ADDENDUM NO. 2

**For
CHICAGO O'HARE INTERNATIONAL AIRPORT
BUILDING 521 RENOVATION FOR AIRPORT POLICE
SPECIFICATIONS AND CONTRACT DOCUMENTS NO. 335805**

CDA Project Number H4018.15-00

A 04 004

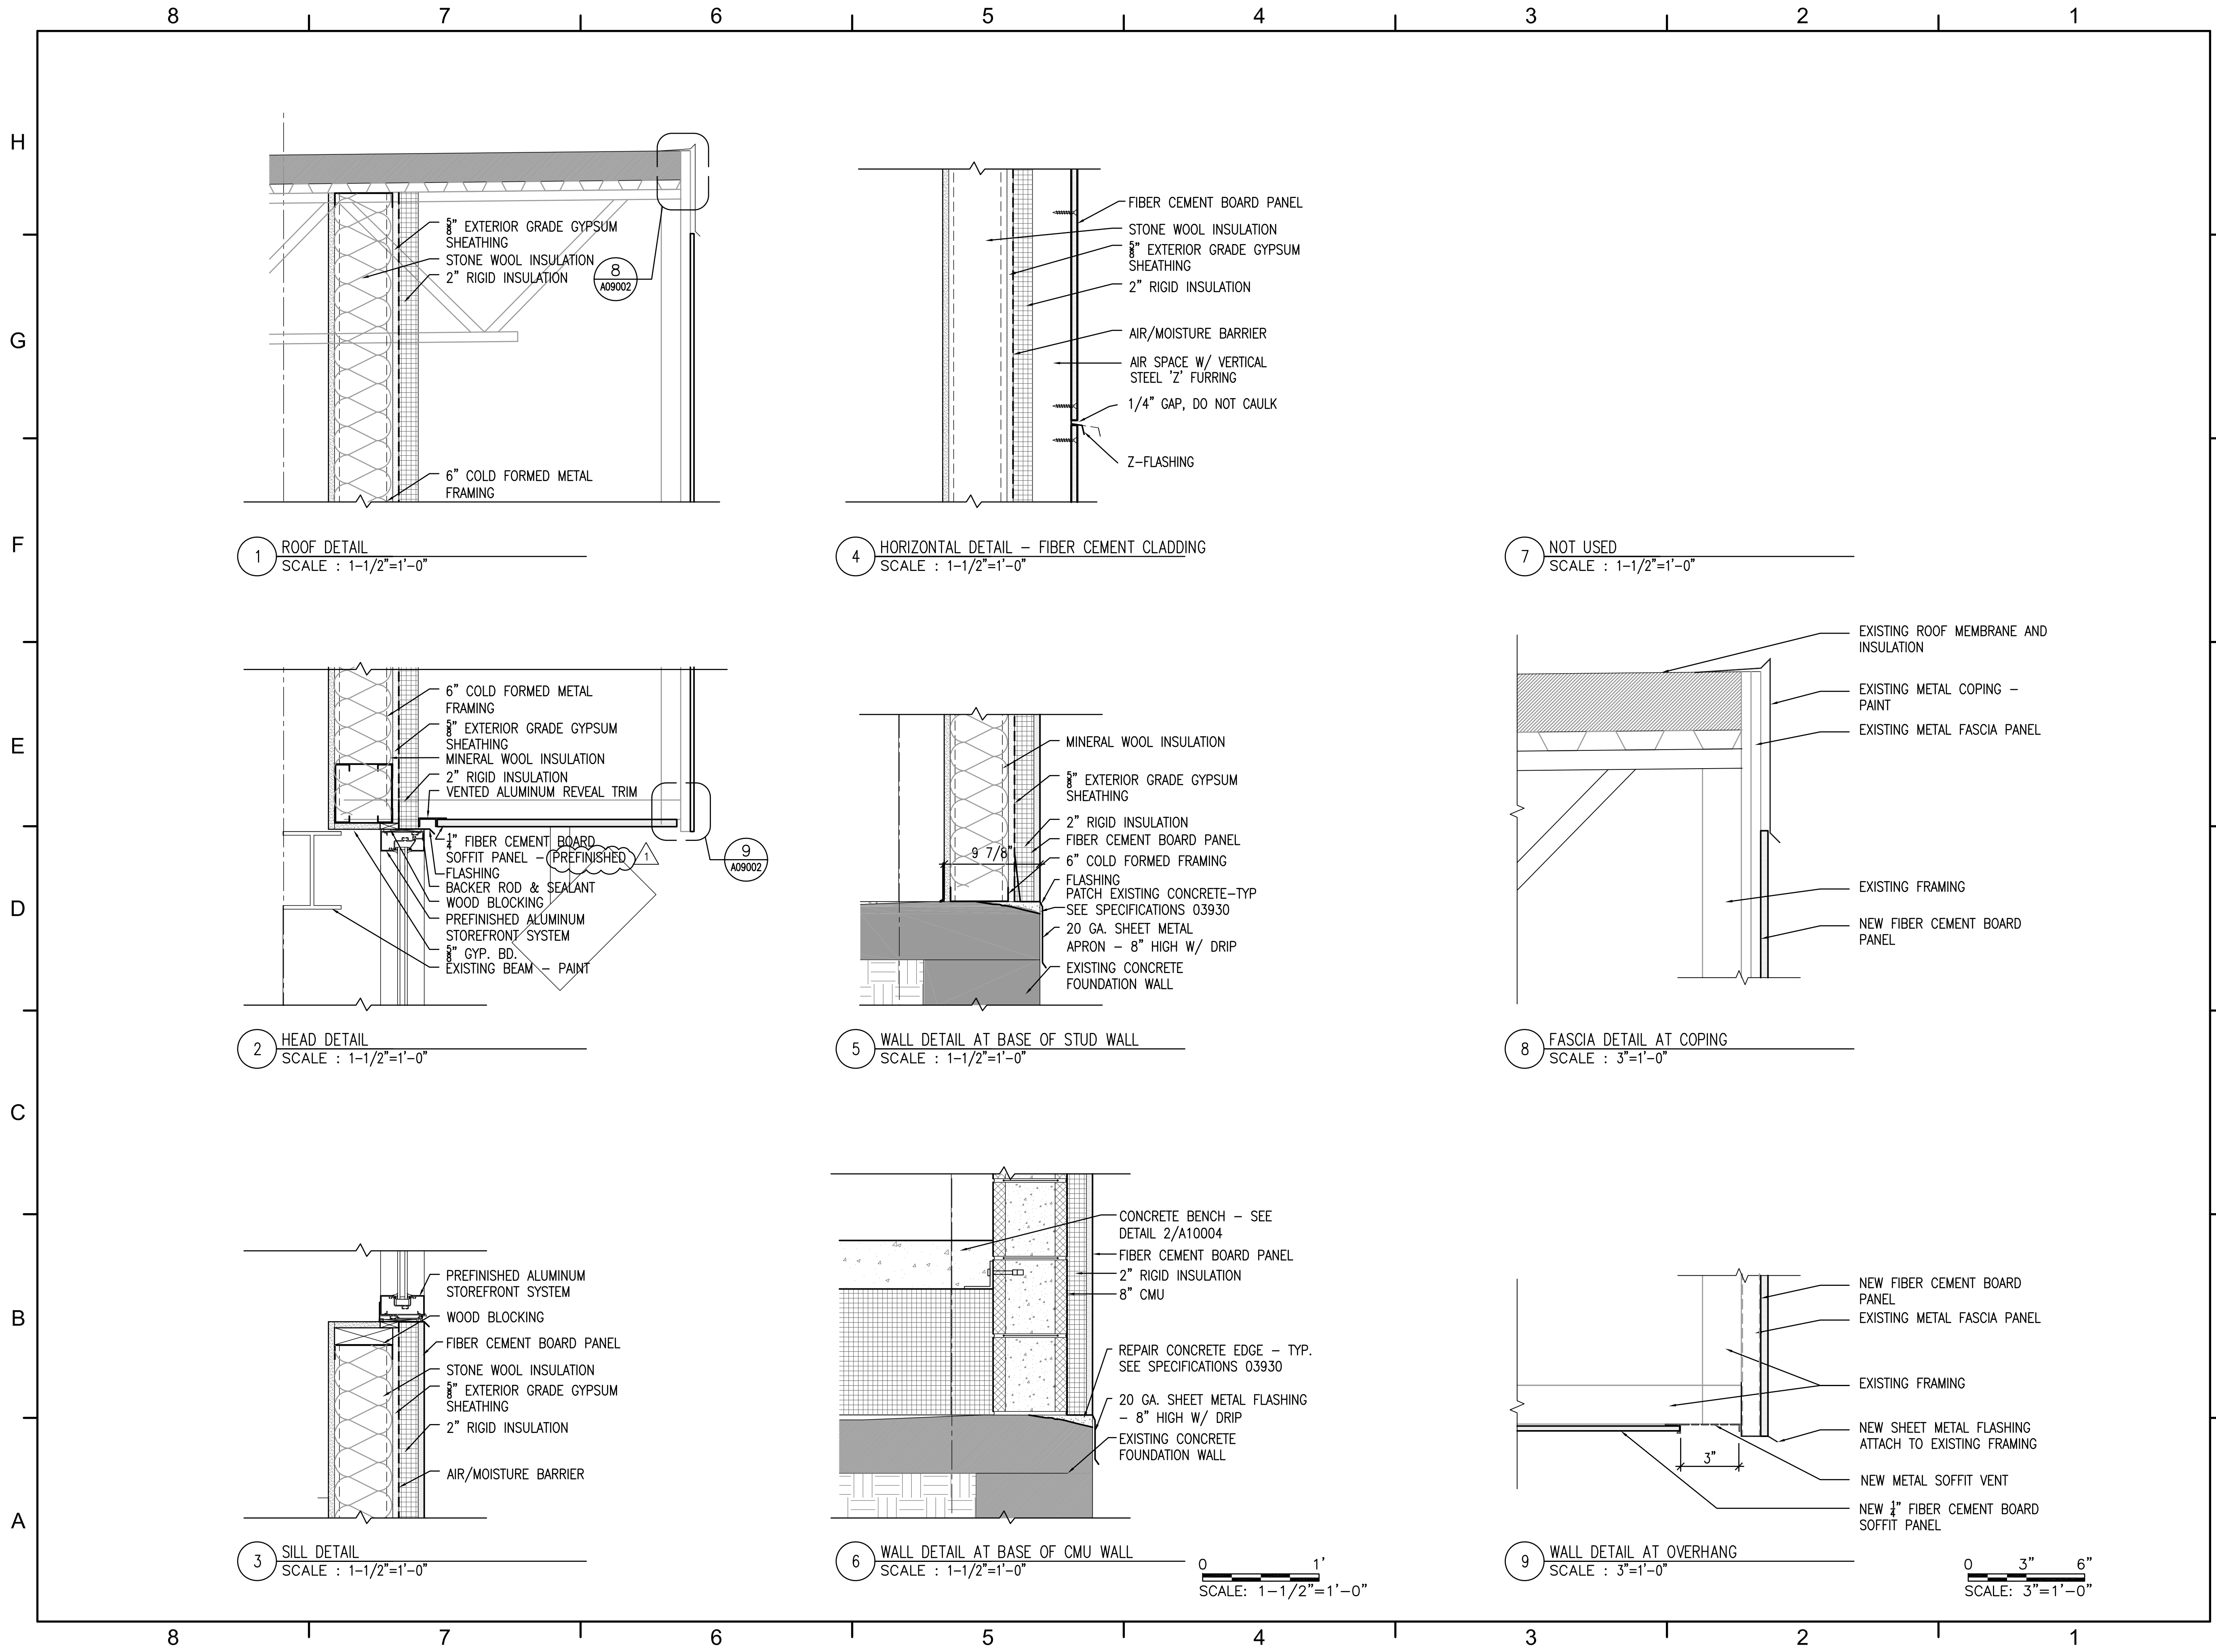
2.A04-003 Details 1 &4	Revised soffit material to read New Fiber Cement Soffit Panel On Existing Framing – Prefinished. (Attached)
3.A04-004 Detail 1	Revised soffit material to read New Fiber Cement Soffit Panel On Existing Framing – Prefinished. (Attached)
4.A009-002 Detail 2	Revised soffit material to read ¼” Fiber Cement Board Soffit Panel – Prefinished. (Attached)
5. A03-003 Door Schedule	Revised to include information on openings 168 and 200A. (Attached)
6. A03-002 Finish Schedule	Revised to clarify floor finishes at rooms 103, 104, 117, 118. (Attached)
